Contract #: 04-0120F4Cty: SF/ALA Rte: 80 PM: 13.2/13.9File #: 69.25B**QUALITY ASSURANCE -- NON-CONFORMANCE REPORT****Location:** Changxing Island, Shanghai, P.R. China**Report No:** NCR-000878**Prime Contractor:** American Bridge/Fluor Enterprises, a JV**Date:** 27-Oct-2010**Submitting Contractor:** Zhenhua Port Machinery Company, Ltd (ZPMC), Changxing Island**NCR #:** ZPMC-0840**Type of problem:**

**Reference Description:** QA found 2 missed UT indications after ZPMC had tested and accepted the weld at Segment 11AE/11BE T-Rib Splices

<b>To:</b>	AMERICAN BRIDGE/FLUOR, A JV 375 BURMA ROAD OAKLAND CA 95607	<b>Date:</b>	29-Oct-2010
<b>Dear:</b>	Mr. Charles Kanapicki	<b>Contract No:</b>	04-0120F4 04-SF-80-13.2 / 13.9
<b>Attention:</b>	Mr. Thomas Nilsson    Project/Fabrication Manager	<b>Job Name:</b>	SAS Superstructure
<b>Subject:</b>	NCR No. ZPMC-0840	<b>Document No:</b>	05.03.06-000835

**Location:** Changxing Island, Shanghai, P.R. China **Report No:** NCR-000880  
**Prime Contractor:** American Bridge/Fluor Enterprises, a JV **Date:** 28-Oct-2010  
**Submitting Contractor:** Zhenhua Port Machinery Company, Ltd (ZPMC), Changxing Island **NCR #:** ZPMC-0842

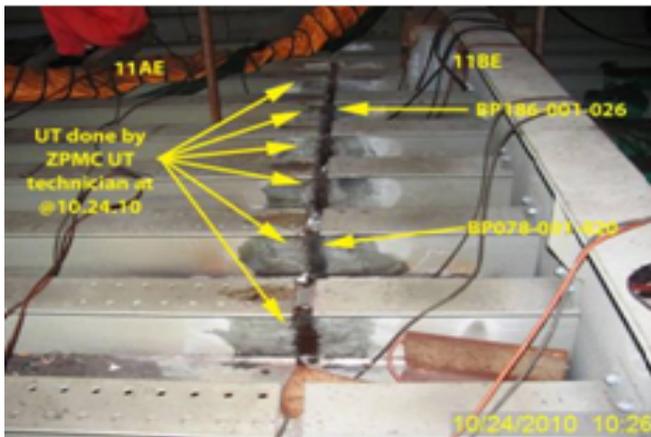
During the Quality Assurance (QA) Ultrasonic Testing (UT) review of welds located on Orthotropic Box Girder (OBG) Segment 11AE to 11BE splice joint, this QA Inspector discovered the following issues:

- Two (2) longitudinal linear Class "A" rejectable indications measuring approximately 20 and 25mm in length.
- The welds are identified as BP186-001-026 and BP078-001-020 respectively.
- Material thickness is 10mm.
- The depth of the indications: approximately 6 and 8mm respectively.
- The indication dBs ratings are +7 and +9 respectively.
- The welds are Complete Joint Penetration (CJP) butt joints, joining bottom plate T-ribs on 11AE to bottom plate T-ribs on 11BE.
- The welds are designated as non Seismic Performance Critical Material (Non SPCM).
- The indications are clearly marked near the welds.
- The Y distance for weld joint BP186-001-026 is 35 mm from bottom cope hole.
- The Y distance for weld joint BP078-001-020 is 45 mm from bottom cope hole.
- The segments are located in the OBG Trial Assembly area.

The Notice of Witness Inspection (NWIT) No. is 007134. The indications are located within an area previously tested and accepted by ZPMC Quality Control (QC) personnel. Per the contract documents, ZPMC's QC personnel are required to perform 25% UT inspection of these welds.

For indication location details, see the attached Photos (The first photo, dated 10/24/10, is included in this incident report for the purpose of confirming that ZPMC QC was previously observed by this QA, performing Ultrasonic Testing (UT) on the welds addressed in this report)

**Reference Resolution:** ZPMC has repaired the indications noted in the NCR and is providing NDT documentation after the repair to show the indication has been removed.

ZPMC has repaired the indications noted in the NCR and is providing NDT documentation after the repair to show the indication has been removed. ABFJV has noted which inspector was responsible for this missed indications and is monitoring his performance as well as all inspector performance, if he continues to miss indications disciplinary action will be undertaken. Based on these actions, ZPMC requests closure of this NCR.

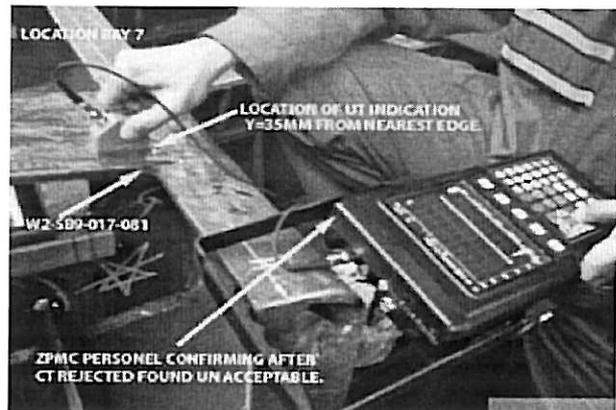
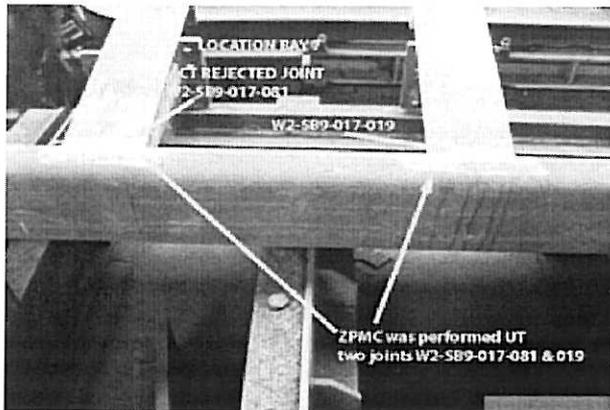
During the Quality Assurance (QA) Ultrasonic Testing (UT) review of weld located on the Steel Barrier (SB), this QA Inspector discovered the following issue:

- One Class "A" rejectable indication measuring approximately 10 mm in length.
- The indication rating is -4dB.
- The depth of the indication was 5-6 mm
- The weld joint is identified as W2-SB9-017-081.
- This weld is a Complete Joint Penetration (CJP) splice joint, joining SB Skin plate to the Diaphragm Flange plate.
- The thickness of the steel material is 12 mm.
- The "Y" location is approximately 35 mm from the nearest end of the weld.
- The indication is clearly marked on or near the weld.
- This SB is located in sub assembly Bay # 7.

The Notice of Witness Inspection Number (NWIT) is 07136. The indication is located within the area that has been previously tested and accepted by ZPMC Quality Control (QC) personnel. As per the contract documents, ZPMC's QC personnel are required to perform 10% UT inspection of this weld.

ZPMC acknowledged the indication was missed and has issued an internal NCR to address this problem. ZPMC has repaired the indication and is providing the NDT records to show the acceptance of this weld. Based on this, ZPMC is requesting closure of this NCR.

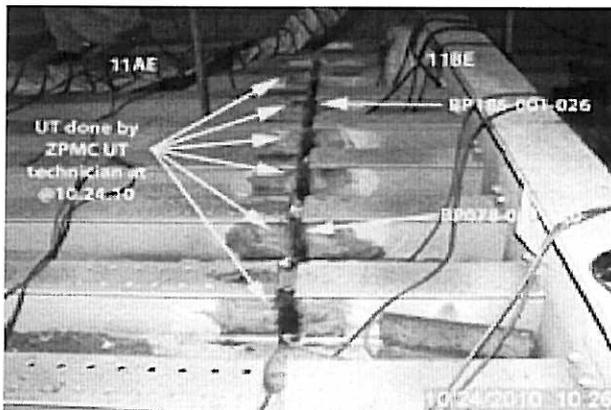
During the Quality Assurance (QA) Ultrasonic Testing (UT) review of welds located on Orthotropic Box Girder (OBG) Segment 11AE to 11BE splice joint, this QA Inspector discovered the following issues:

- Two (2) longitudinal linear Class "A" rejectable indications measuring approximately 20 and 25mm in length.
- The welds are identified as BP186-001-026 and BP078-001-020 respectively.
- Material thickness is 10mm.
- The depth of the indications: approximately 6 and 8mm respectively.
- The indication dBs ratings are +7 and +9 respectively.
- The welds are Complete Joint Penetration (CJP) butt joints, joining bottom plate T-ribs on 11AE to bottom plate T-ribs on 11BE.
- The welds are designated as non Seismic Performance Critical Material (Non SPCM).
- The indications are clearly marked near the welds.
- The Y distance for weld joint BP186-001-026 is 35 mm from bottom cope hole.
- The Y distance for weld joint BP078-001-020 is 45 mm from bottom cope hole.
- The segments are located in the OBG Trial Assembly area.

The Notice of Witness Inspection (NWIT) No. is 007134. The indications are located within an area previously tested and accepted by ZPMC Quality Control (QC) personnel. Per the contract documents, ZPMC's QC personnel are required to perform 25% UT inspection of these welds.

For indication location details, see the attached Photos (The first photo, dated 10/24/10, is included in this incident report for the purpose of confirming that ZPMC QC was previously observed by this QA, performing Ultrasonic Testing (UT) on the welds addressed in this report)

ZPMC to repair the indications noted in the NCR and provide NDT documentation to confirm the indications removed and repaired. The inspector involved has been identified and his performance will be closely monitored. Appropriate disciplinary action will be taken should his performance is not improved in future.
